DART SERVICE INSTRUCTION

TO AMEND INSTALLATION INSTRUCTIONS IIN-D058-676 REV. A AND
INSTRUCTIONS FOR CONTINUED AIRWORTHINESS ICA-D058-676 REV. 0
REF: FAA STC: SR01018SE

FIGURE 1 - CROSSTUBE SUPPORT

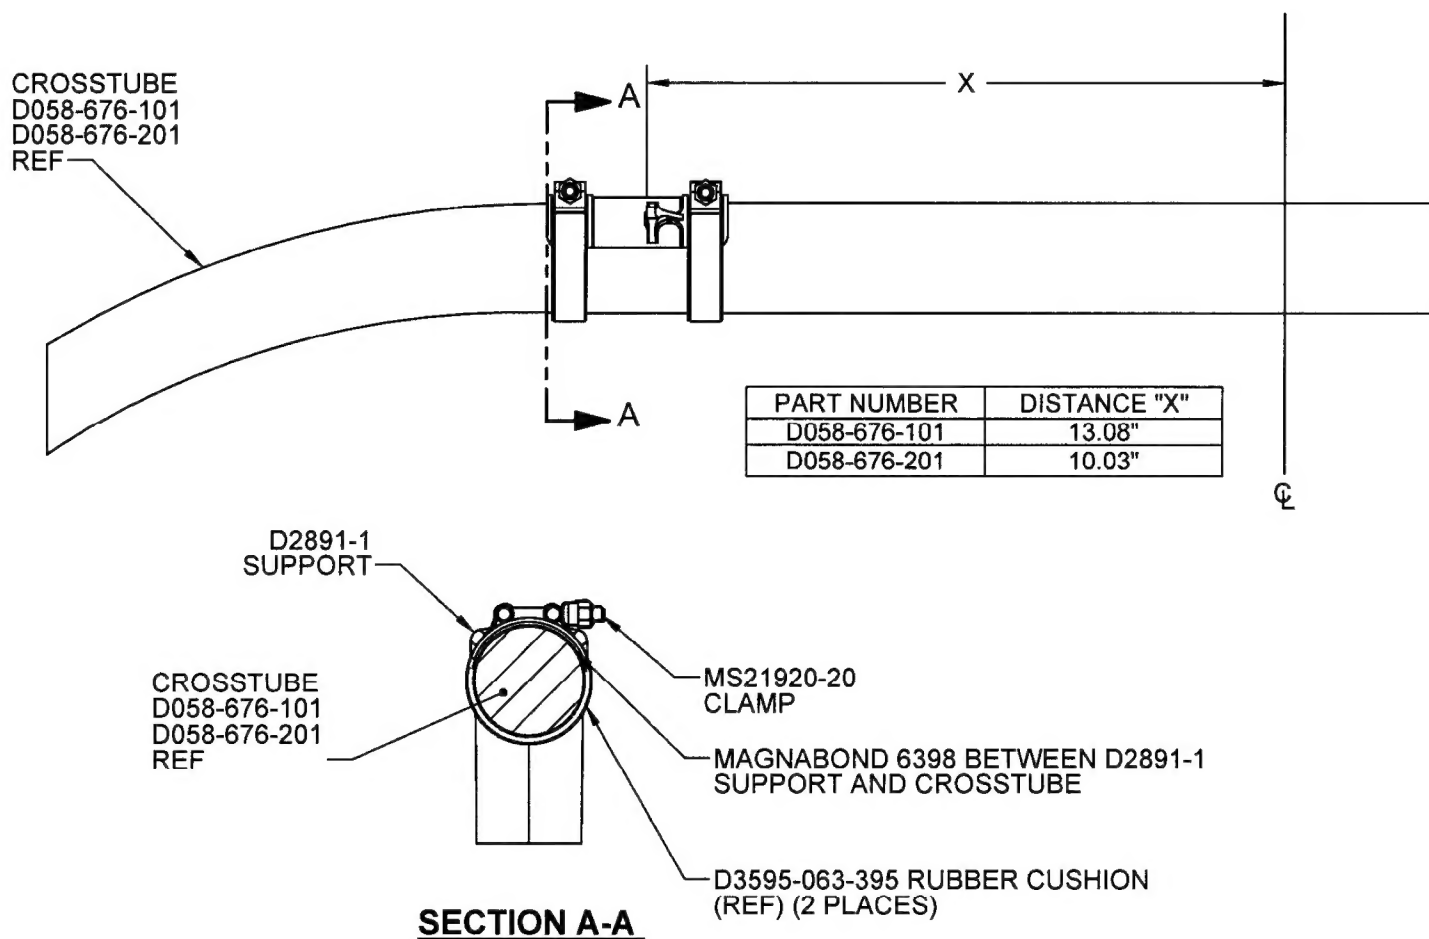
For D058-676-101/-201 crosstubes at CHG 002 or later, the D2856-400-694 abrasion strips have been removed, the D2891-1 supports have been bonded onto the crosstube using Magnabond 6398 and D3595-063-395 Rubber Cushions have been installed underneath the MS21920-20 Clamps. Amend parts list of the IIN-D058-676 Section 5 and ICA-D058-676 Section 32.8 as follows:

To prevent the supports from shifting on the D058-676-101/-201 crosstubes at CHG 001, the D2891-1 supports should be removed and re-installed as follows:

- 6) Apply a 0.03" to 0.06" thick layer of Magnabond 6398 underneath each D2891-1 support and re-install the support on the crosstube as shown in Figure 1. Position and secure the D2891-1 supports on the crosstube using MS21920-20 Clamps. Install a D3595-063-395 Rubber cushion underneath each MS21920-20 Clamp. Torque clamps 80-100 in-lb. Let the D058-676-101/-201 crosstube assembly cure as per the Magnabond 6398 instructions before re-installing the crosstube on the aircraft.
